Staff Report

Devens
Enterprise
Commission

RE: 16 Bulge Level 2 Unified Permit Public Hearing

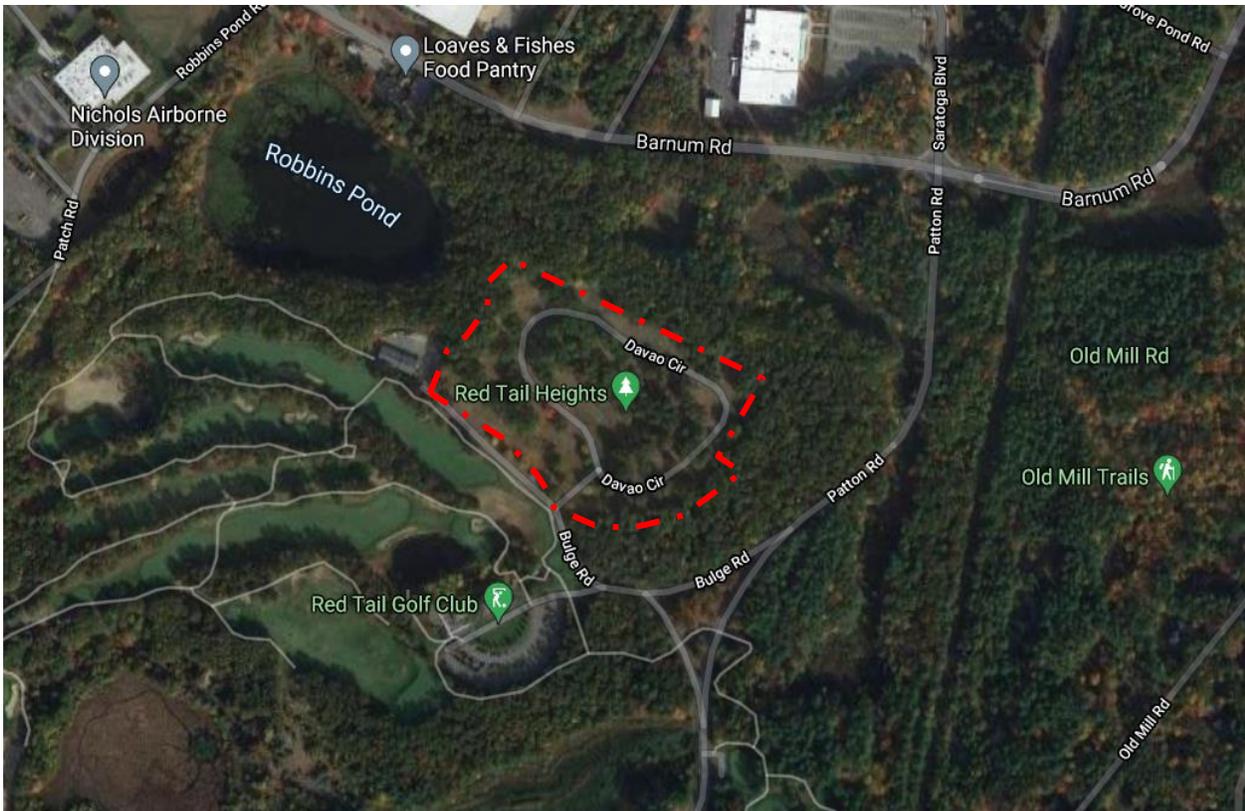
Screening: MassDevelopment, in collaboration with the Applicant, has suggested they pursue a waiver from 974CMR 3.04(3)(a)1(a) to allow greater than 10% of their parking in front of the facility. The reason for this is to limit the views of the facility from the Red Tail Golf Course. The Applicant is installing berms replete with landscaping to further buffer the facility from the Golf Course and to allow the Applicant to utilize some of the soils generated by the development. Staff concurs with the granting of this waiver if the area where pavement was removed parallel to Bulge Road is bermed and landscaped to provide year round buffer to a height of 6'.

A stone dust trail system restricted to employees is proposed around the edges of the plateau. They will be designed to retain the historic World War 1 trench system found at the north by northwest portion of the top of the slope resource area. Would the Applicant allow access to the trail loop along the back of the Golf Maintenance facility to Bulge Road that traverses a small portion of their property where your property borders the Golf Course Maintenance facility? Staff has requested the Applicant consider reducing the one way truck loop from 20' to 14' and the Applicant has stated they would like to retain the wider aisle width. Staff suggests 14' of pavement with 6' reinforced turf. Consider extending public sidewalk west towards Patton to connect with trail coming from north.

Overall, VHB concludes that the proposed project with the mitigation measures in place will have minimal impacts to traffic operations at the study area intersections. Are sidewalks connecting to the trail system at the intersection of Patton and Bulge and/or bike lanes contemplated? Bike racks are shown on the plans and a future stop for the Devens Shuttle is contemplated. Patton Road is a truck route and portions of it are constrained by wetlands.

Lighting: DEC Regulation require 0.5 footcandles for walkways and driveways. Staff has worked with the Applicant to review the lighting plan to ensure compliance with 974 CMR 3.04 and 4.04. They propose to keep all exterior lighting on overnight. Staff would recommend justifying the need for all lighting all night long and would welcome a more nuanced appraisal.
